ALA4 - Replacing the Fuel Supply Line in the Engine Compartment (Delivery Stop / Recall Campaign)

Vehicle Type: **Cayenne Turbo (9YA) / Cayenne Turbo Coupé (9YB) / Cayenne Turbo S E-Hybrid Coupé (9YB)**

Subject: **Fuel supply line in the engine compartment**

Installation location of fuel supply line

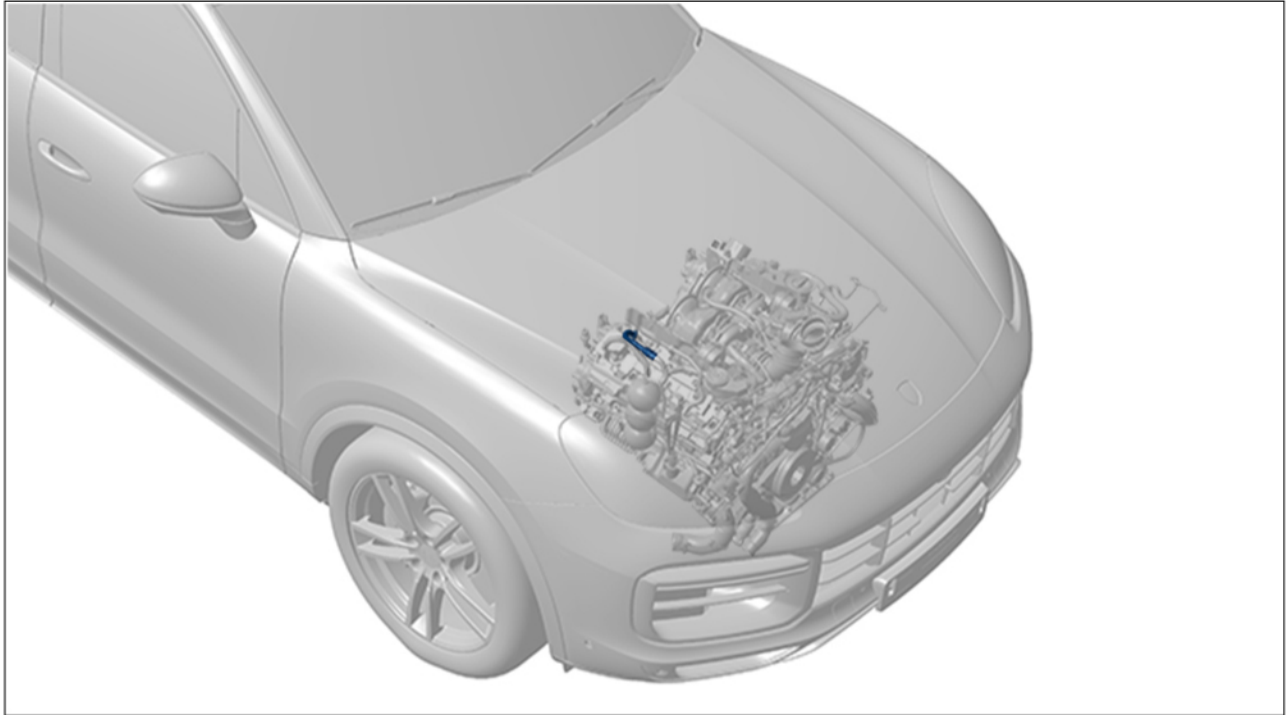
Information: **Due to a weakness in the quick connector component on the fuel supply line, the leak-tightness of the quick connector may not be guaranteed at very high engine compartment temperatures on affected vehicles.**

As a result, fuel may leak from the quick connector on the fuel supply line, which can be perceived as an odor.

Remedial Action: **Replace fuel supply line in the engine compartment.**

Removing fuel supply line

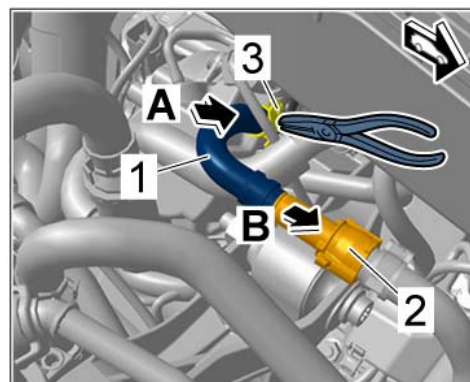
- 1.1 Press release buttons ⇒ *Removing fuel supply line -arrow A-* and then briefly press quick connector ⇒ *Removing fuel supply line -2-* towards the fuel connection piece to release the quick connector. Then pull the quick connector from the fuel connection piece ⇒ *Removing fuel supply line -arrow B-*.
- 1.2 Collect escaping fuel.
- 1.3 Loosen spring band clamp ⇒ *Removing fuel supply line -3-* at the fuel line connection using suitable pliers and then detach the fuel line.

During installation, please observe the installation marking on the fuel line and on the steel line.

- 2 Install a new fuel supply line ⇒ *Installing fuel supply line -1-*.
 - 2.1 Install fuel supply line using spring band clamp ⇒ *Installing fuel supply line -3-* (⇒ *Installing fuel supply line -arrow A-*).
 - 2.2 Push quick connector ⇒ *Installing fuel supply line -2-* onto fuel adapter ⇒ *Installing fuel supply line -arrow B-* until it engages securely with an audible click.
